Access Compliance Report

Public Rights-of-Way

(Pedestrian Signals)

Intersection ID: N/A	Main Street:	Cross Street: N/A	Location: N/A
ADA ID: 3967004387D3	Signal Type: Two Push Buttons-Non APS	Overall Compliance: No	Severity Score: BTN 1:N/A BTN 2: N/A No BTN: N/A
Codes/Mitigation Info/Possible Solution		Field Measurements/Component Compliance

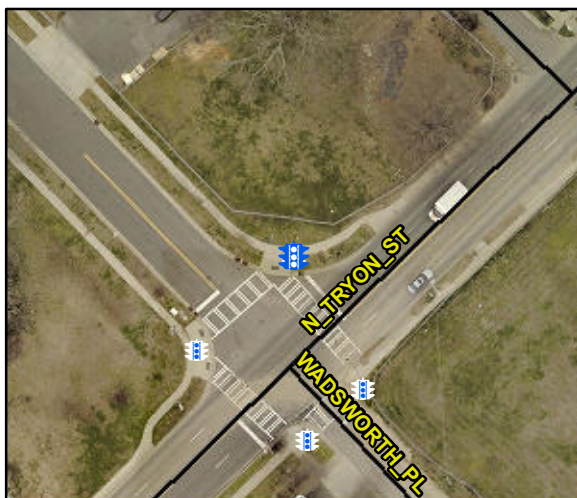
Surveyor Notes: TEXT HT 1/2

Compliance	Description	Data	Compliance	Description	Data
	Button Count	Button2	N/A	Distant to Additional Button (in)	N/A
	Additional Button Present?	N/A		Additional Button ID	N/A
N/A	Signal Buttons Required?	N/A	N/A	Additional Ped Posts Required	N/A
	How Many Ped Street Xings?	2		Located In An Island/Median?	No
N/A	B 1 Sign Present?	Yes	N/A	B 2 Sign Present?	Yes
Yes	B 1 Sign Purpose?	Yes	Yes	B 2 Sign Purpose?	Yes
No	B 1 Sign Lettering & Contrast?	No	No	B 2 Sign Lettering & Contrast?	No
Yes	B 1 Parallel To XWalk?	Yes	Yes	B 2 Parallel To XWalk?	Yes
Yes	B 1 PAR to Button?	Yes	Yes	B 2 PAR to Button?	Yes
Yes	B 1 PAR to XWalk?	Yes	Yes	B 2 PAR to XWalk?	Yes
Yes	B 1 Clear Floor Space?	Yes	Yes	B 2 Clear Floor Space?	Yes
N/A	B 1 FWD Approach?	Yes	N/A	B 2 FWD Approach?	Yes
N/A	B 1 FWD Approach Constrained?	No	N/A	B 2 FWD Approach Constrained?	No
No	B 1 FWD Approach Reach (in)	9.0	No	B 2 FWD Approach Reach (in)	6.0

N/A	B 1 FWD Approach Width (in)	N/A	N/A	B 2 FWD Approach Width (in)	N/A
N/A	B 1 FWD Approach Obstruction?	Yes	N/A	B 2 FWD Approach Obstruction?	Yes
N/A	B 1 FWD Approach Obstruction Dist (in)	3.5	N/A	B 2 FWD Approach ObstructionDist (in)	2.0
N/A	B 1 PARA Approach?	Yes	N/A	B 2 PARA Approach?	Yes
N/A	B 1 PARA Approach Constrained?	No	N/A	B 2 PARA Approach Constrained?	No
Yes	B 1 PARA Approach Reach (in)	9.0	Yes	B 2 PARA Approach Reach (in)	5.0
N/A	B 1 PARA Approach Width (in)	N/A	N/A	B 2 PARA Approach Width (in)	N/A
N/A	B 1 PARA Approach Obstruction?	Yes	N/A	B 2 PARA Approach Obstruction?	Yes
N/A	B 1 PARA Approach Obstruction Dist (in)	3.5	N/A	B 2 PARA Approach ObstructionDist (in)	1.0
No	B 1 Clear Floor Space Slope (%)	4.1	Yes	B 2 Clear Floor Space Slope (%)	0.5
No	B 1 Clear Floor Space XSlope (%)	3.7	No	B 2 Clear Floor Space XSlope (%)	9.1
N/A	B 1 PAR Slope (%)	2.3	N/A	B 2 PAR Slope (%)	1.0
Yes	B 1 Height (in)	38.0	Yes	B 2 Height (in)	38.0

Yes	B 1 Clear Xing Direction?	ClearlyMarked	Yes	B 2 Clear Xing Direction?	ClearlyMarked
	B 1 Crossing Direction	To SW		B 2 Crossing Direction	To SE
Yes	B 1 DistanceTo XWalk (in)	0.0	No	B 2 DistanceTo XWalk (in)	65.0
No	B 1 DistanceTo Curb (in)	96.0	No	B 2 DistanceTo Curb (in)	90.0
Yes	B 1 Diameter (in)	2.0	Yes	B 2 Diameter (in)	2.0

Possible Solutions: Replace Signal Push Button With APS Button on New Post. Remove & Replace Sign.
